Office Action Summary

10/717,110

This is the second office action for application number 10/717,100, Modified Spring System End Cap for Packaging Fragile Articles Within Shipping Cartons, filed on November 19, 2003.

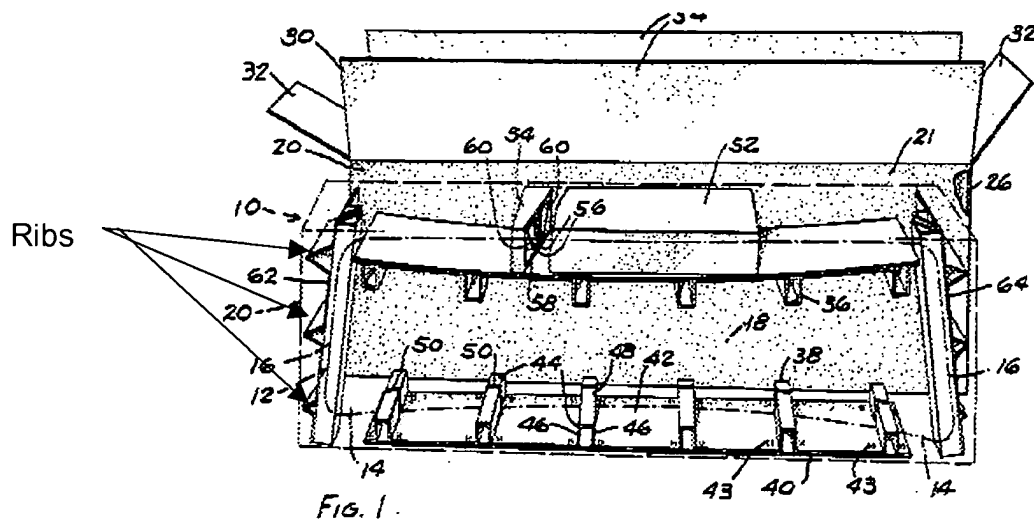
Azelton et al. '796 discloses a spring system end cap (figures 1A, 1B) comprising a platform portion (4), a sidewall structure (6,8) having a length and including an inner wall (10) connected with the platform portion and surrounding the periphery of the platform portion, and an outer wall (12) forming an acute angle relative to the platform portion and surrounding the periphery of the inner wall, at least one spring system (14) connected between the inner wall and the outer wall wherein the spring system includes at least one bellows (20), wherein the sidewall structure includes a plurality of the spring systems formed end to end, wherein each spring system is connected with the outer wall along a ridge forming a plurality of arcs (see figure 1B) connected end to end along

the length of the sidewall structure, wherein Azelton et al. '796 additionally teaches a system for supporting an article including first and second end caps as previously described (see figure 2).

However, Azelton et al. '796 fails to specifically teach at least one rib protruding from the outer wall. Nevertheless, Lidgard '534 divulges an end cap for supporting an article (figures 1,2, see above), wherein the end cap includes ribs (above) protruding from an outer wall. It would have been obvious to one of ordinary skill in the art at the time the invention was made to have included ribs on the outer wall of Azelton et al. '796 as in Lidgard '534 so as to allow the end caps along with an object being held by the end caps to more closely conform to the inside of a carton or box which would provide for a more stable assembly. Further, it would have been obvious to have provided ribs on each of the spring systems so as to provide for an even more stable assembly, in addition to the fact that doing so is simply seen as a duplication of parts.
